**Planning & Zoning Commission  
Tuesday, February 3, 2026, 6:00 PM  
Public Meeting Room / Eagle Town Hall  
200 Broadway, Eagle, CO 81631**

## STAFF REPORT AND CERTIFICATE OF RECOMMENDATION

**PROJECT:** Mountain Tots Preschool, Major Development Permit

**FILE NUMBER:** DR25-07

Figure 2: Site Plan

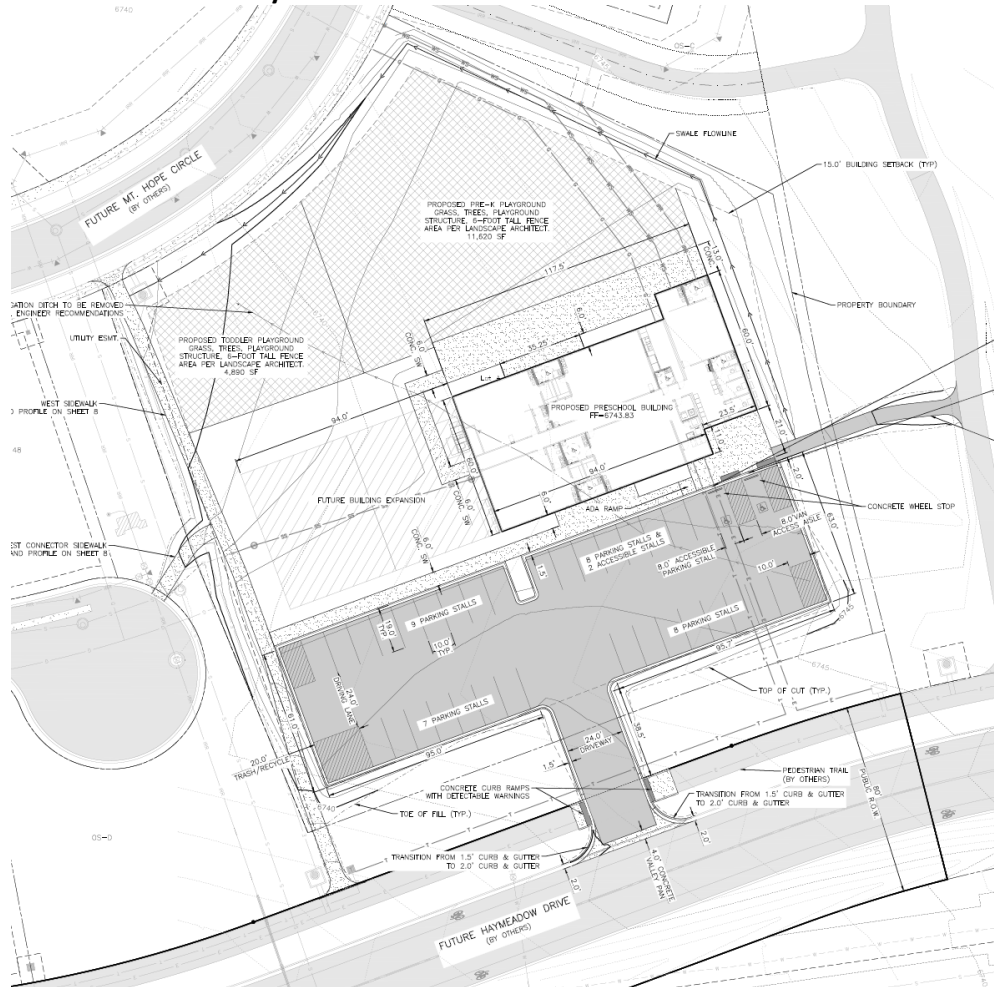
**Staff Comment:** The entrance to the site is from Haymeadow Drive and allows efficient access and wayfinding by emergency services. The proposed development is positioned on the property to avoid steep slopes, natural drainageways, natural hazards, wildlife habitat, utility easements, and defined view corridors. There is no significant grade change on the property and the structure is generally placed at the high point and parallel to topographic lines. Additionally, the building is sited to allow efficient and safe access from the parking area to entry points, with parking provided immediately adjacent to the primary entrance on the building's southern facade. The building is positioned to maximize privacy of its outdoor spaces, access to quality views, and opportunities for solar applications. Trash enclosures on the southwest corner of the lot, in the parking area, will be bear resistant per their [DRB Submittal Plan Set](#) page 7 and will be screened from public view with a cedar fence, which will be treated with a semi-transparent wood stain to ensure weatherization. The rooftop HVAC system on the north side of the structure is being screened from public view with decorative standing seam flat panel metal roofing.

The proposed development's façade will consist of segmented horizontal imitation wood siding, stone veneers, and stucco. Segmented horizontal siding and stone are included as permitted façade materials with color-treated metal permitted as an accent wall surface. Stucco is not specifically included in the permitted façade materials list; however, additional materials of equivalent durability as approved by the Director are permissible. Staff's research of this material indicates, if installed properly, stucco has at least a 20-year durability expectancy, if not longer. As a condition of approval, at the time of building permit, the applicant must provide the manufacturer's specification sheet clearly specifying its ability to withstand the Town's variable mountain climate to ensure maintenance and durability.

The façade colors are compatible with the natural setting and hearken to the general color palette of the existing and proposed residences in Haymeadow Neighborhood A1. Both the roof and façade materials have low reflectivity. A sidewalk connection is provided on the eastern side of the property, immediately north of the parking lot, and it connects to the trail system leading north and northwest towards Mt. Hope

**Staff Comment:** The parking plan for the proposed development is described in the project narrative. The project provides 34 parking spaces. Per the Haymeadow PUD Guide, the project is required to have one spot per 300 square feet plus four drop off spaces, totaling approximately 24 parking spaces. While the drop off spaces are not marked on the site plan, the provided parking more than exceeds the minimum standard. The off-street parking stalls are 9 feet wide and 19 feet long, except for the ADA accessible parking spot that is 8 feet wide plus the access aisle. The applicant has not yet identified where on-site electric vehicle (EV) charging will be provided as required by Section 4.12.040.I., which states that “on-site electric vehicle charging shall be provided in compliance with the Colorado Model Electric Ready and Solar Ready Code as applicable to the Town”. The Town has adopted an Energy Efficiency Offset Program (EEOP) into the Building Code. Staff is including a condition of approval for on-site EV charging.

The intersection of the access way with a public street is approximately 113 feet from the side lot line and the access way between the public street and the parking area is approximately 24 feet wide. Landscaping and pavement curbs clearly define the access way. Additionally, access is provided so vehicles can enter and exit unrestricted in forward drive. Both the grade and the drainage plan for the parking lot have been examined by the Town’s Engineering staff and have been determined to be sufficient. Snow storage is indicated on the Site Plan provided in the [Engineered Site Plan on page 4](#) showing two parking spots immediately to the east of the trash enclosure. The site plan within the Engineered Site Plan indicates the parking lot will be surfaced with asphalt.

1. The applicant shall provide the manufacturer's specification sheet for the stucco at time of building or foundation permit. Stucco spec sheet must make note of the materials' ability to withstand the local climate.

3. If the applicant is required to make changes to the parking plan, those changes will be reviewed administratively at time of building or foundation permit.

4. The applicant shall demonstrate that their long-term bicycle parking meets the intent of the Association of Pedestrian and Bicycle Professionals (APBP) Essentials of Bike Parking guidelines through secure and weather protected measures.
5. The applicant shall provide an access agreement for the driveway and utility lines.
